The Banks – Phase 3C
Public Infrastructure Development
Bid Package #2 – Lot 28 Park & Garage
January 13, 2022
THP #98090.40

ADDENDUM #2

DRAWING TITLE
UPPER LANDING
DISPLAY & SEATING

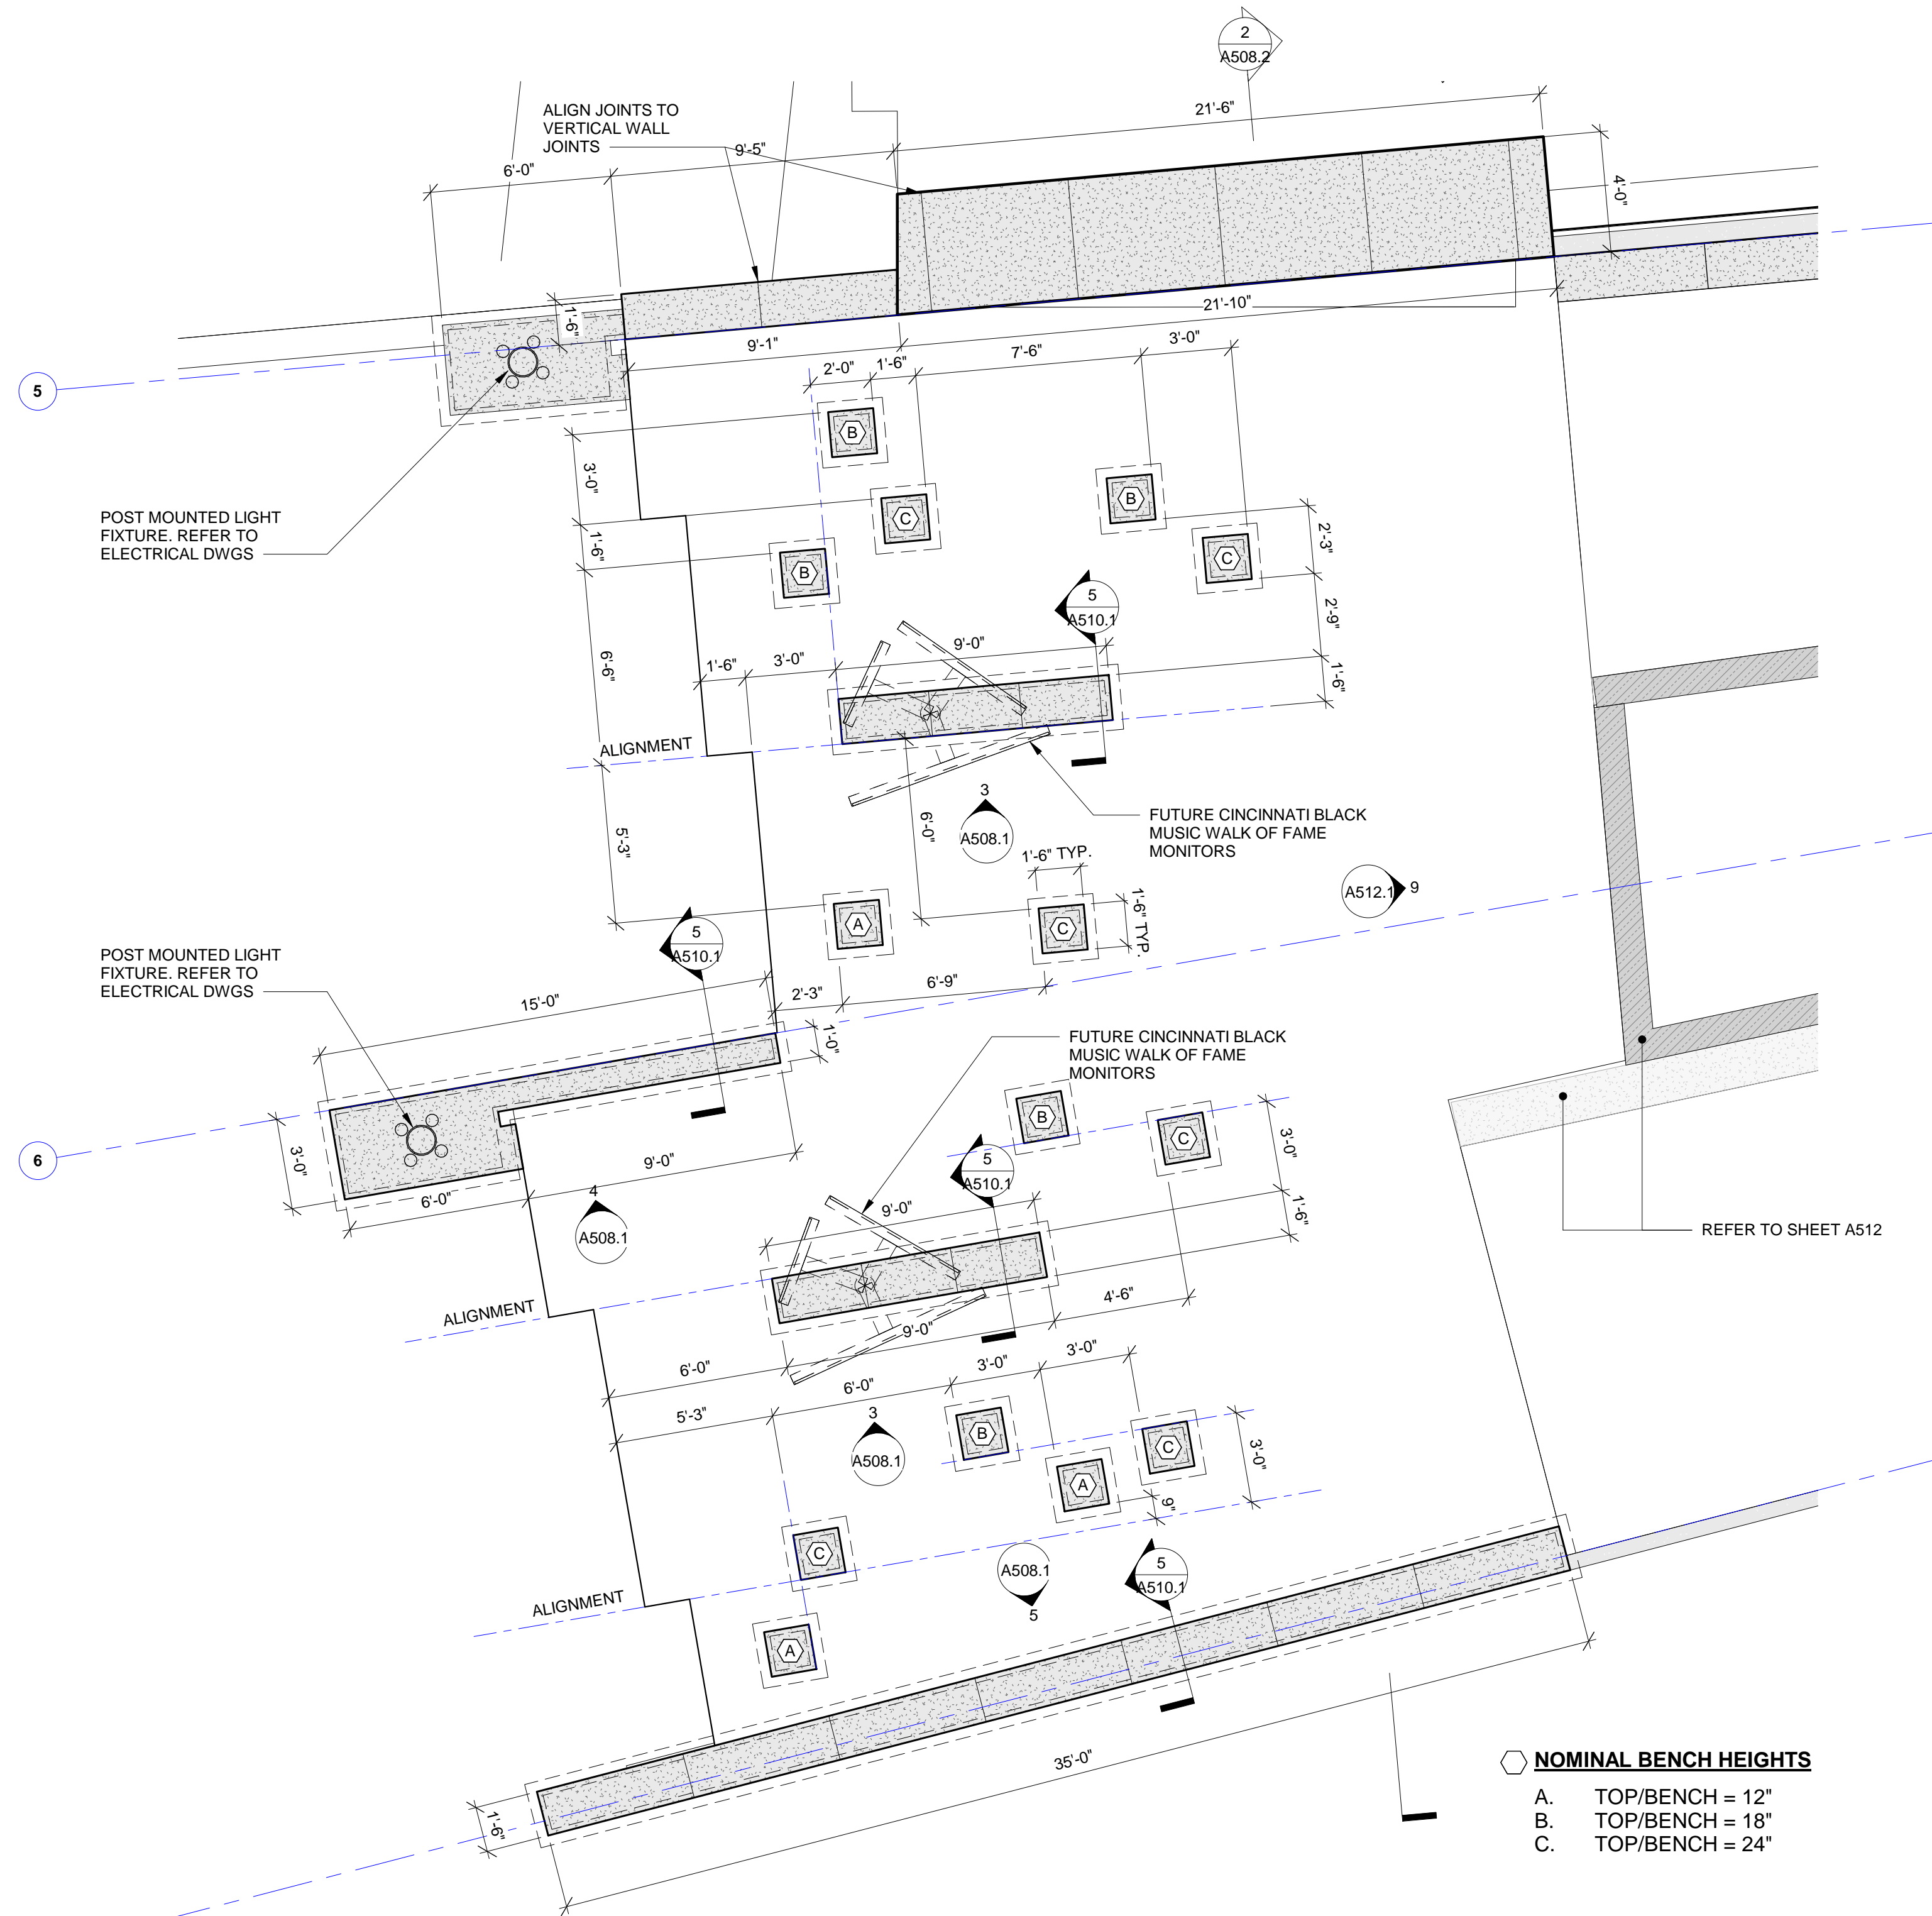
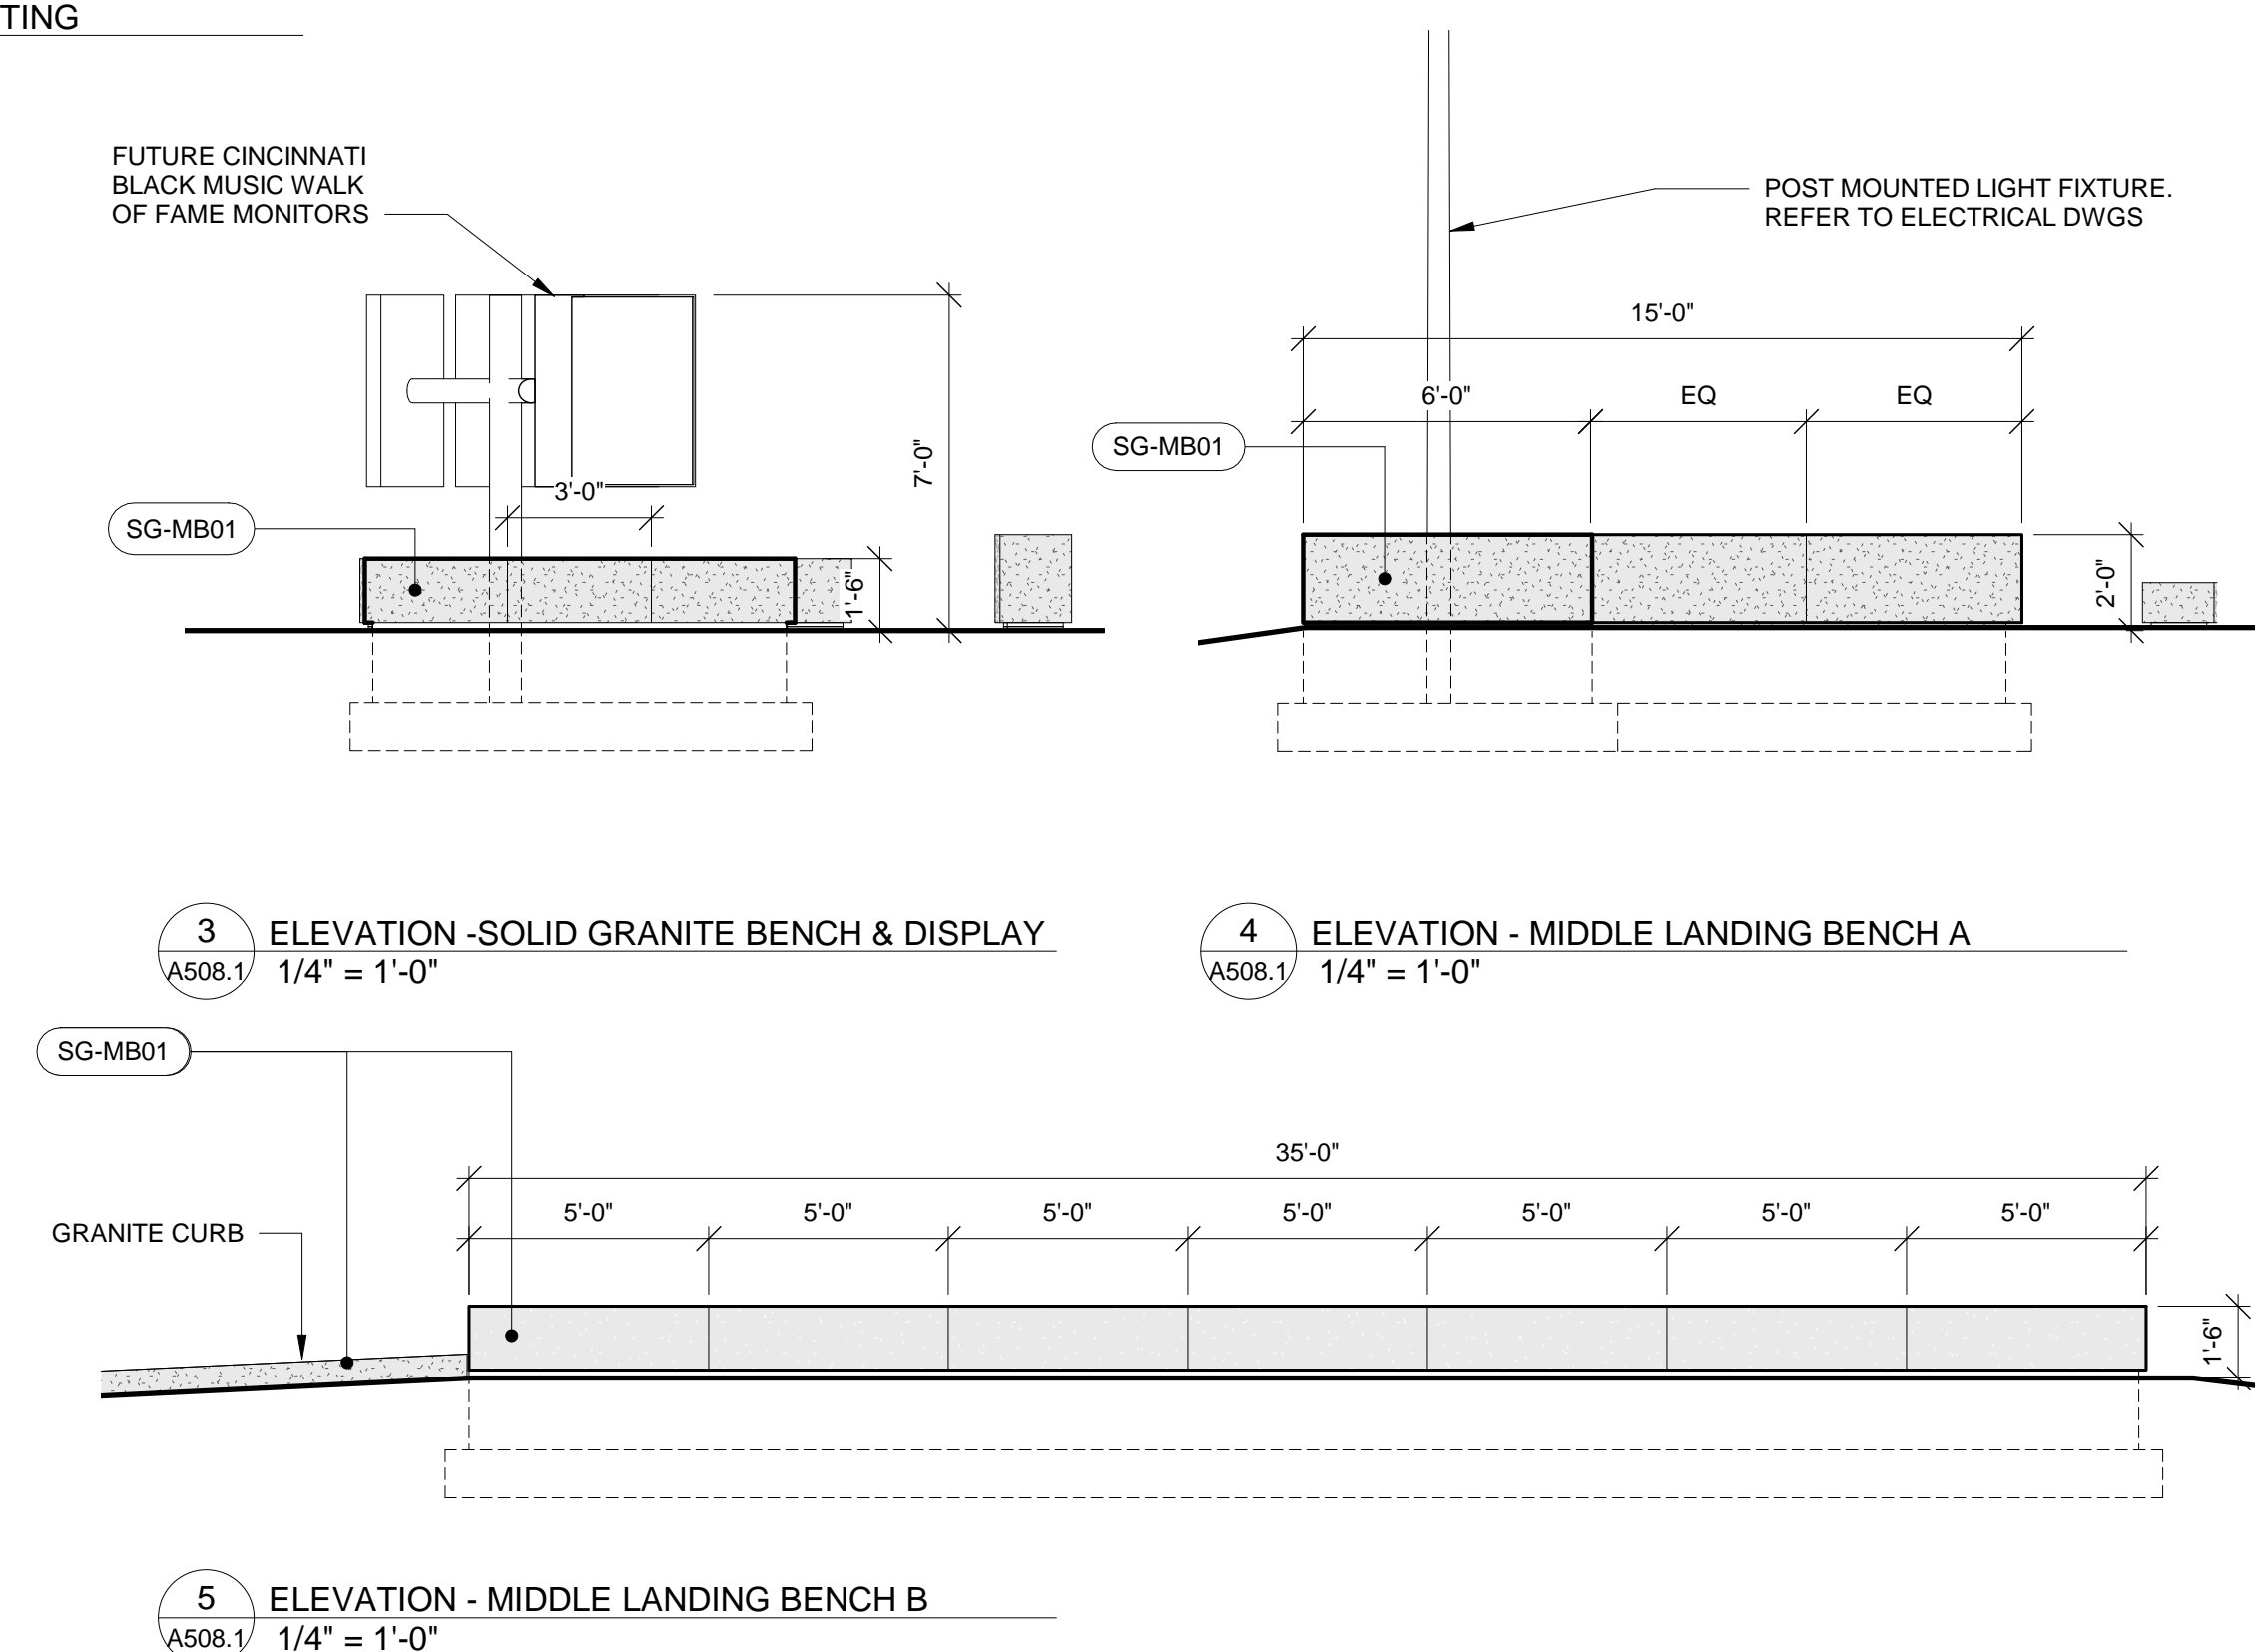
- Added new sheet to address upper landing bench (plans/elevations)
